MONITORING YEAR 6 ANNUAL REPORT

VILE CREEK MITIGATION SITE

Alleghany County, NC
DEQ Contract No. 5999
DMS Project No. 96582

RE: Response to Monitoring Year 6 (MY06) Report – Draft Submittal Comments
Vile Creek Mitigation Site
DMS Project # 96582
Contract Number 5999
New River Basin - HUC# 05050001 - Alleghany County, North Carolina

APPENDIX 2. Visual Assessment Data

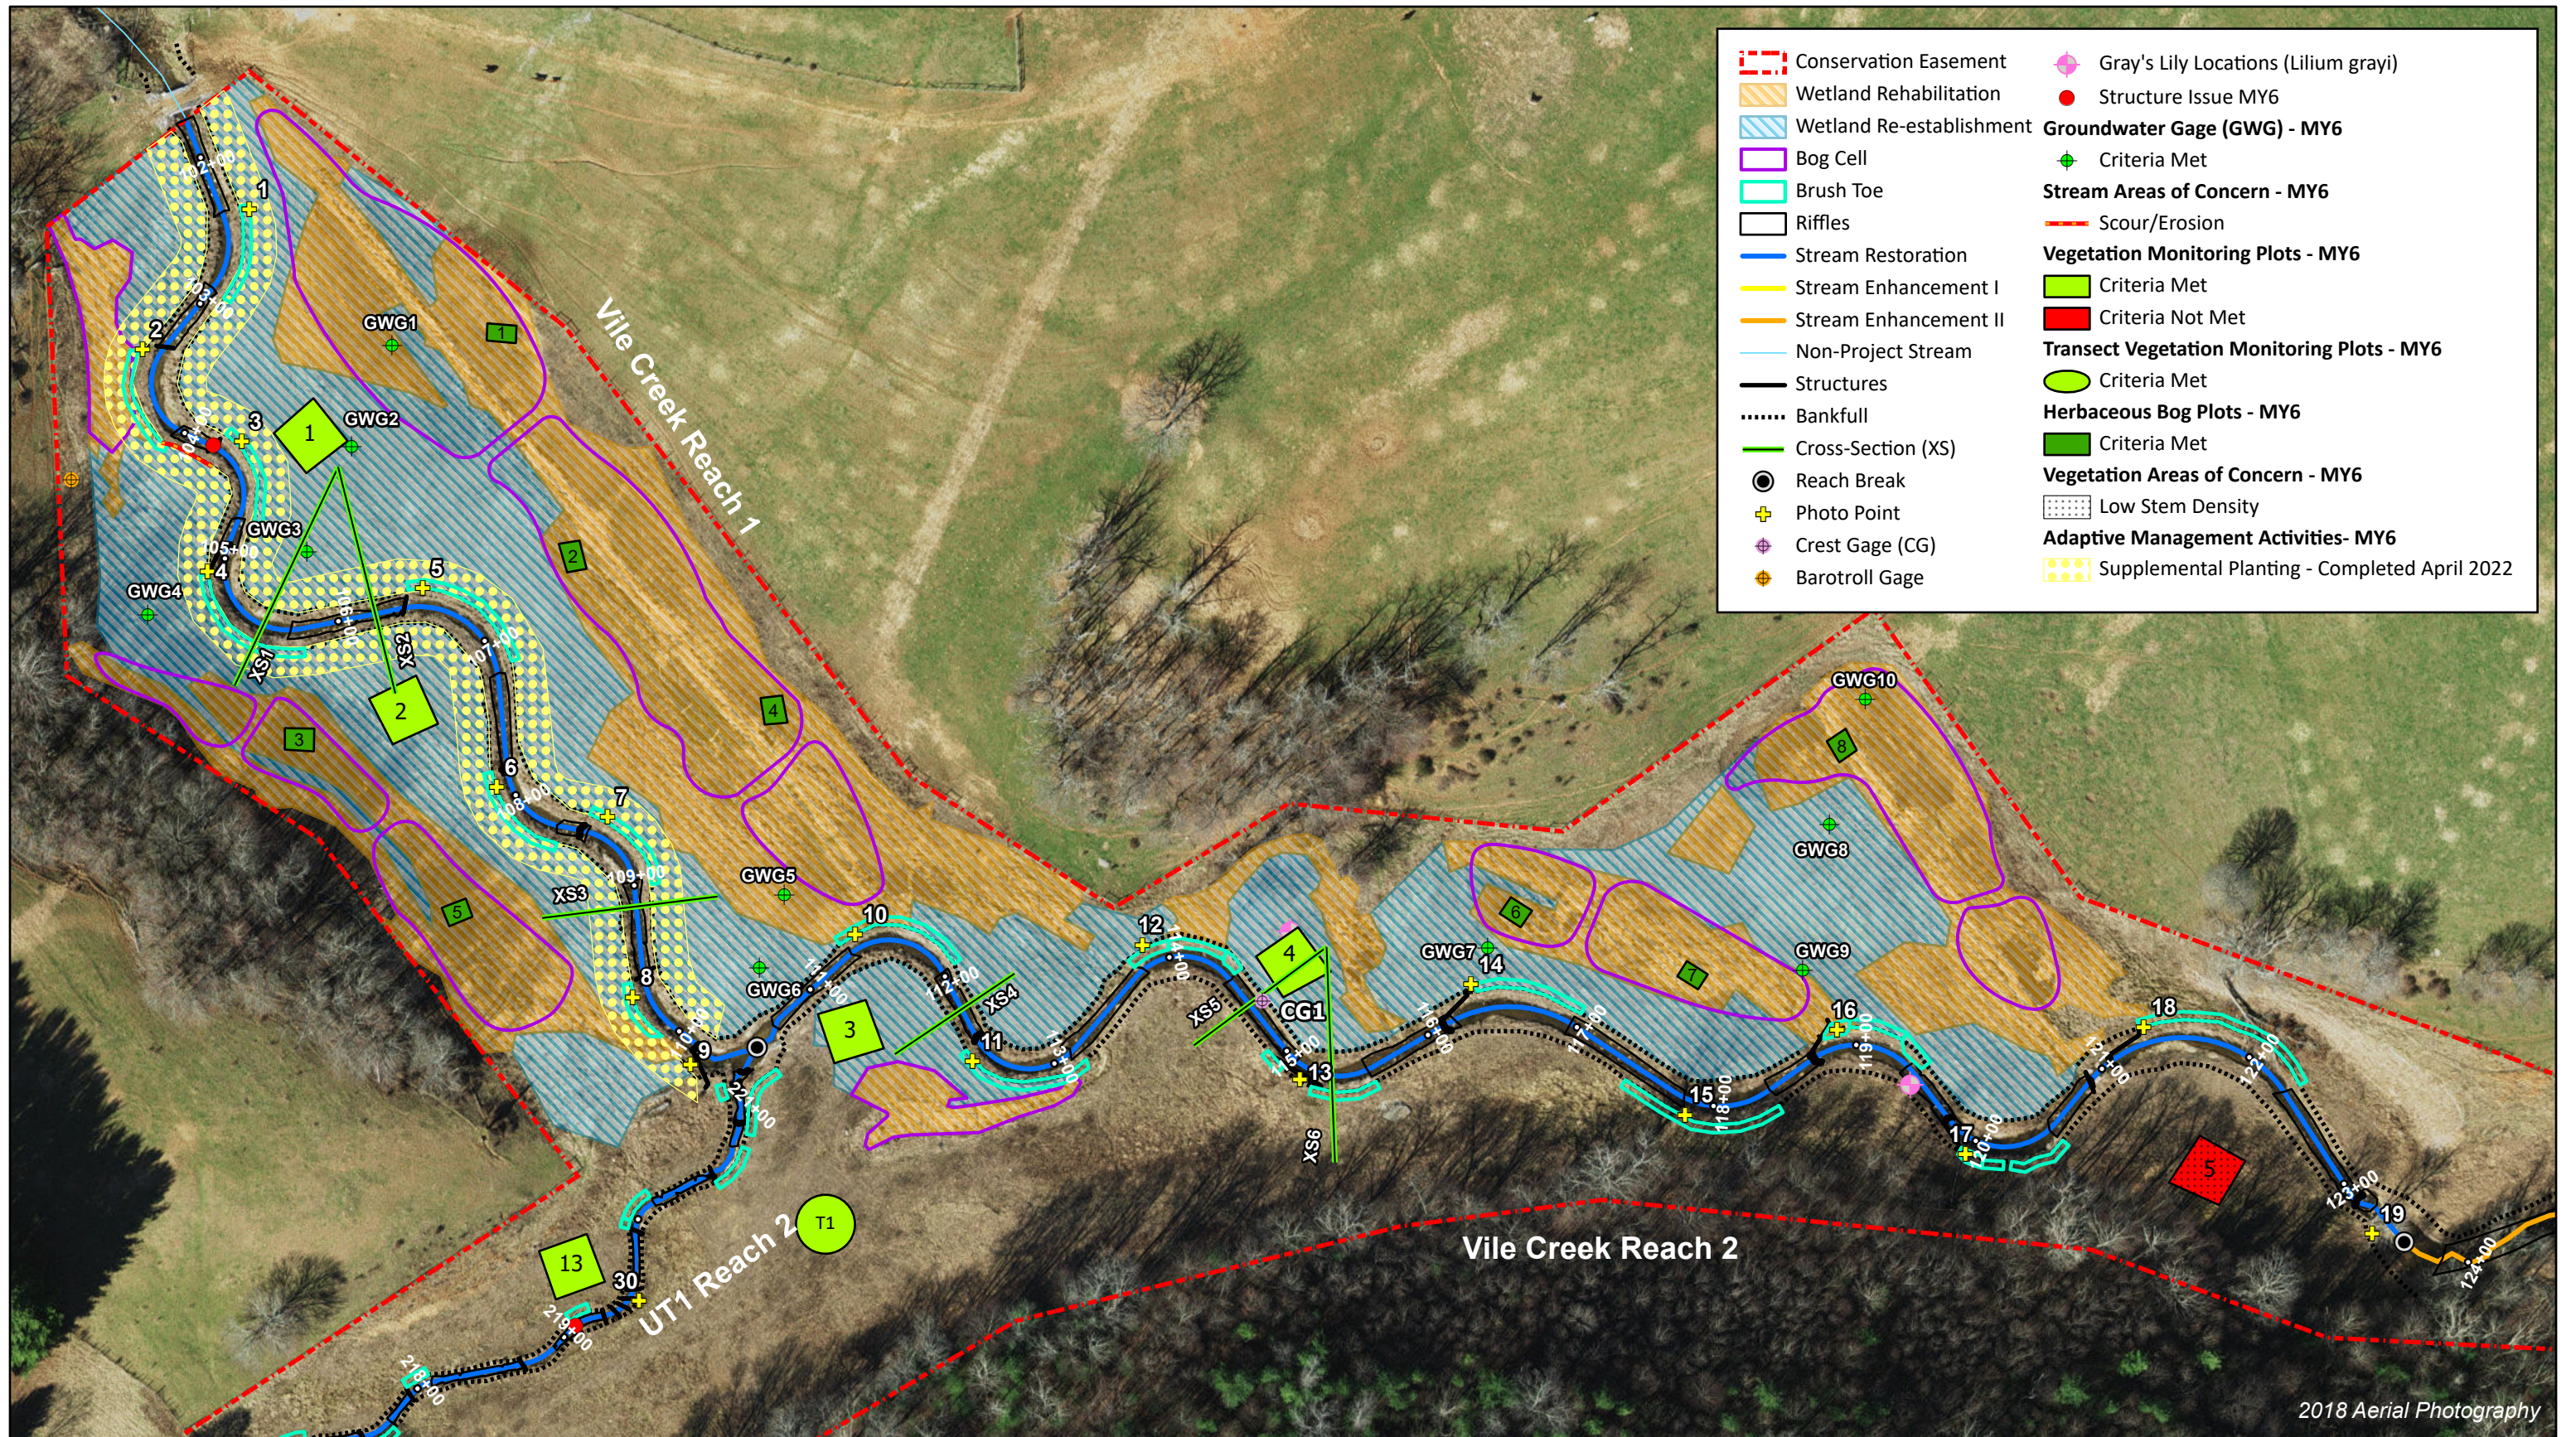
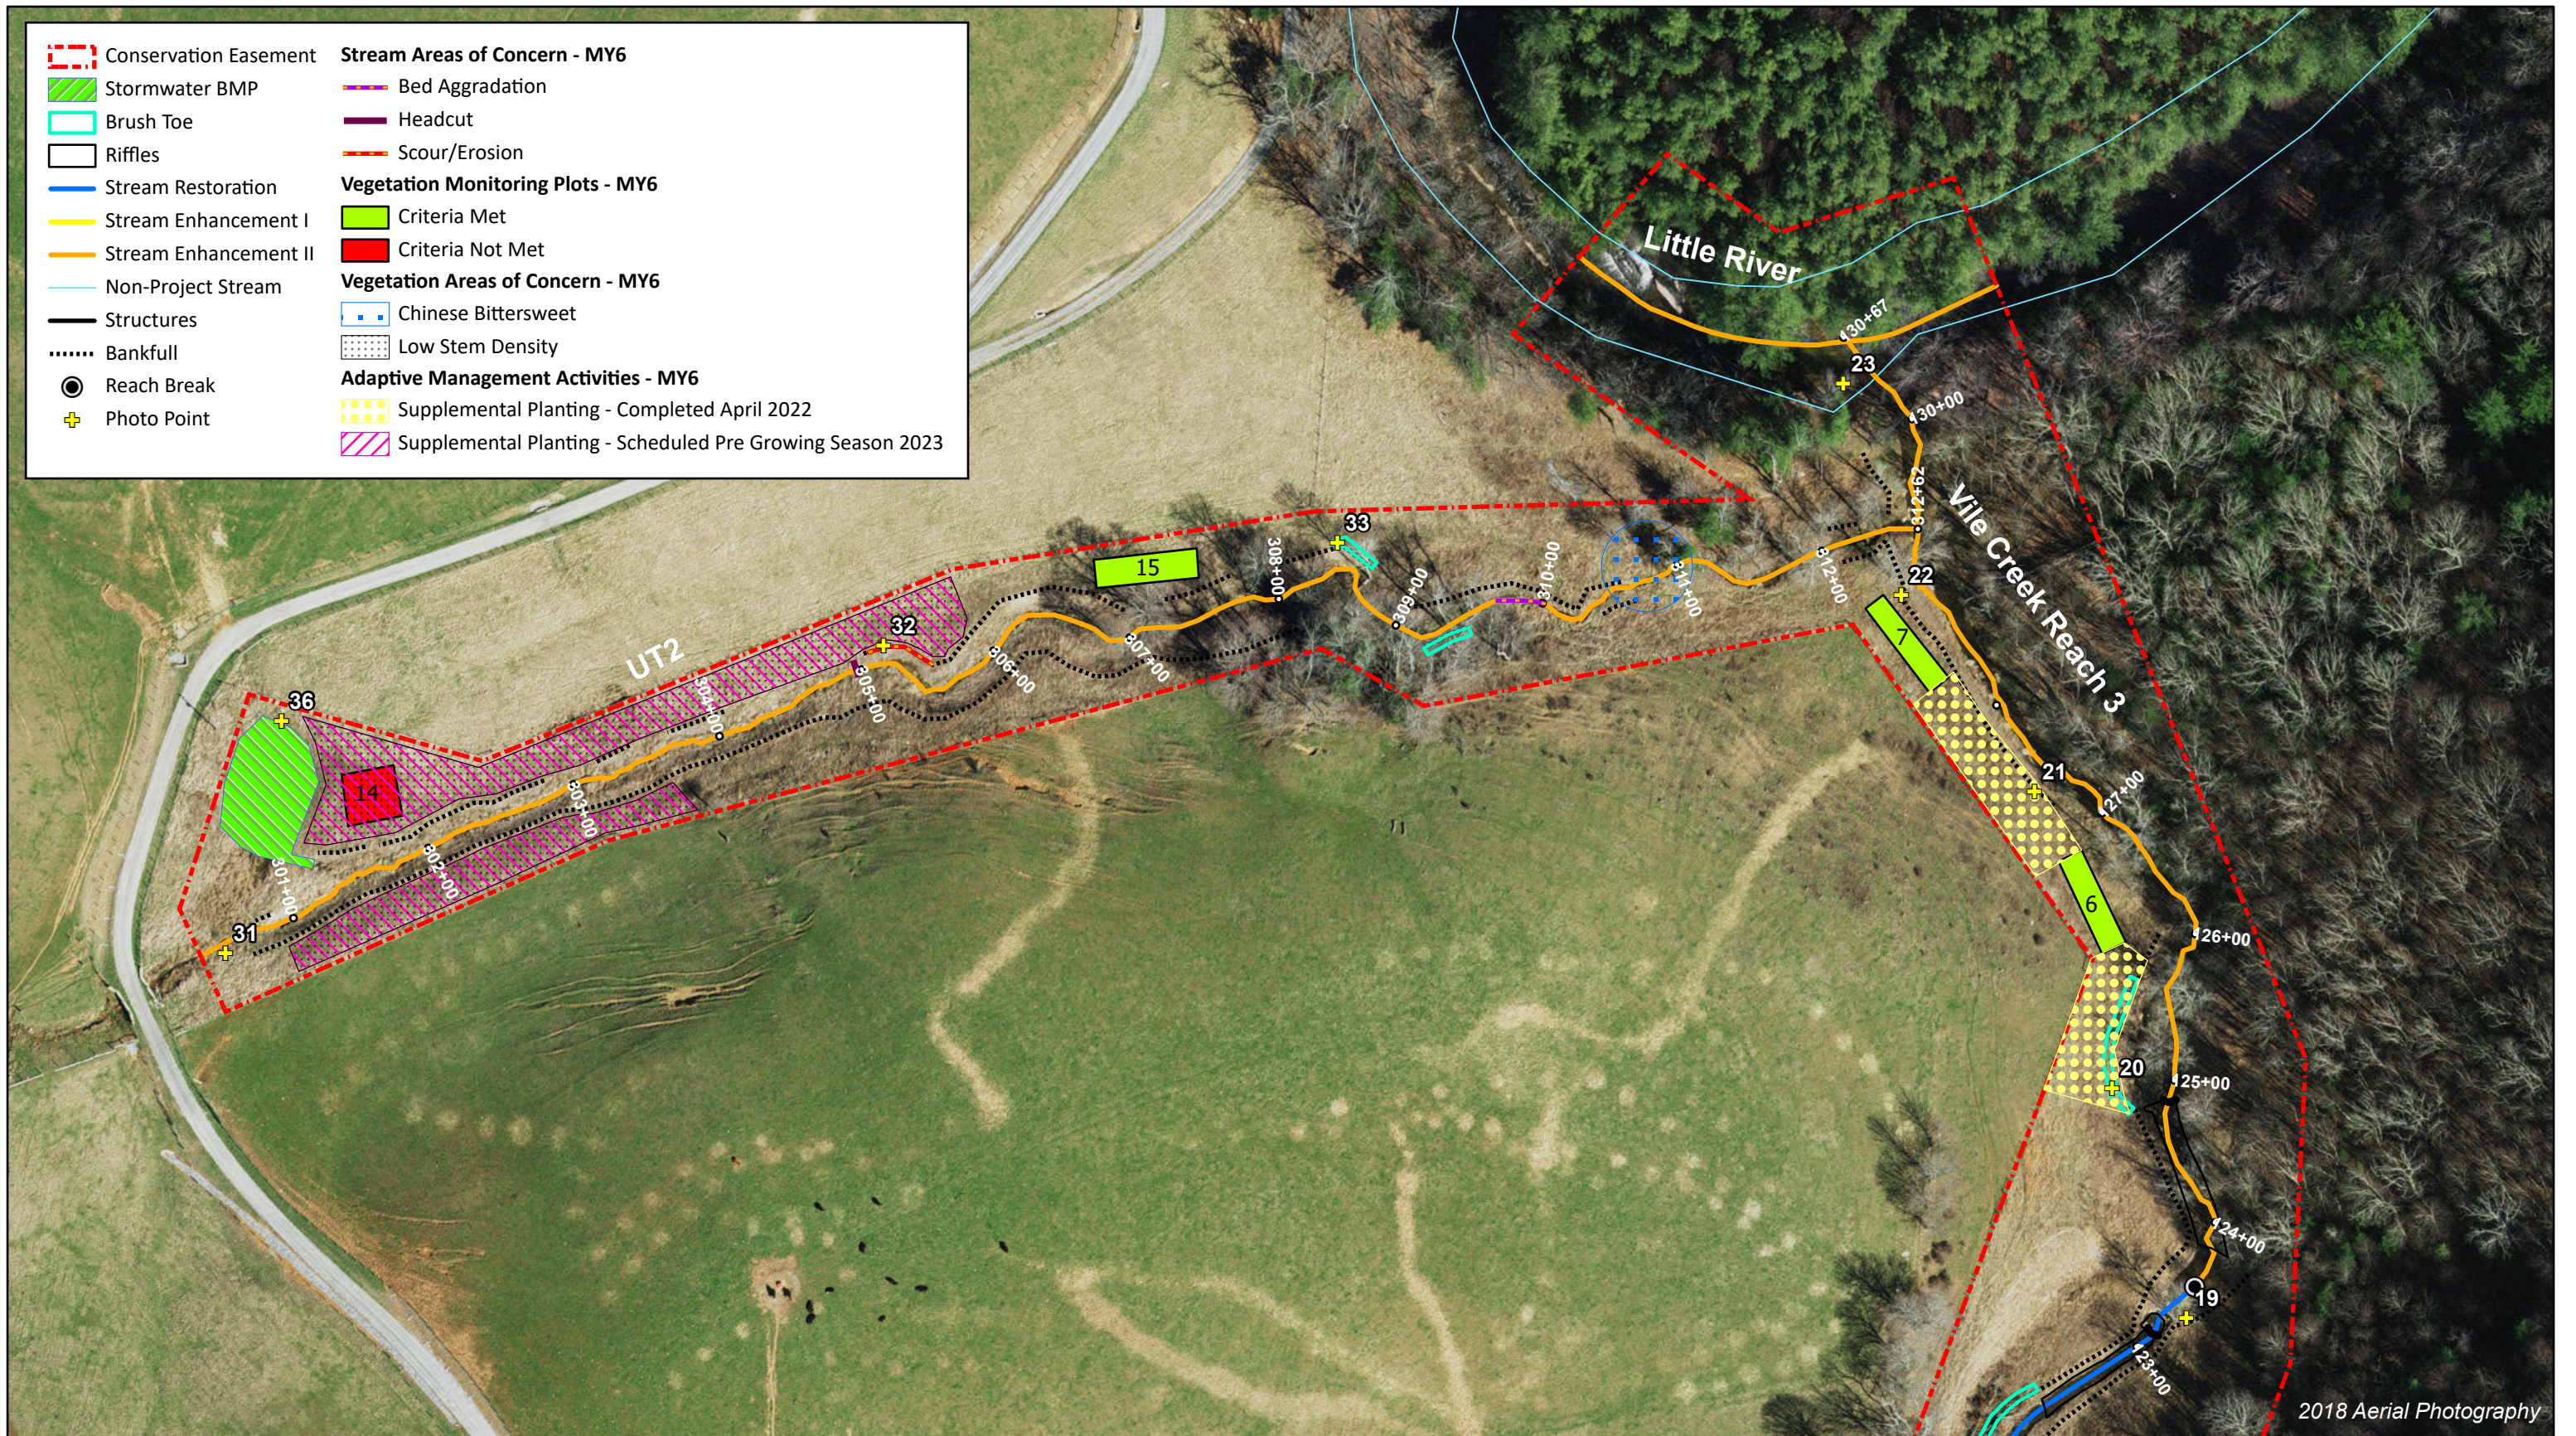
At the 2022 credit release IRT meeting, WEI noted that UT2 will be supplementally planted in the future. The CCPV did not reflect any supplementally planting along UT2. Please advise or clarify.

Wildlands Response: Additional supplemental planting will occur before the onset of the 2023 growing season in low stem density areas on Site (approximately 1 acre) including an area along the left bank of UT1, and upstream sections of UT2. The areas will be replanted with one, three, and/or five-gallon containerized trees. Species will include those approved in the Vile Creek Mitigation Site Final Mitigation Plan and 2021 Vile Creek Mitigation Site Adaptive Management Plan (Wildlands 2016, 2021). The planted species, sizes, wetland indicator status, and quantities will be documented in the MY7 monitoring report. Refer to CCPV Figures 3.1 and 3.3 in Appendix 2 and Section 1.2.5 for supplemental planting locations and low stem density acreages.
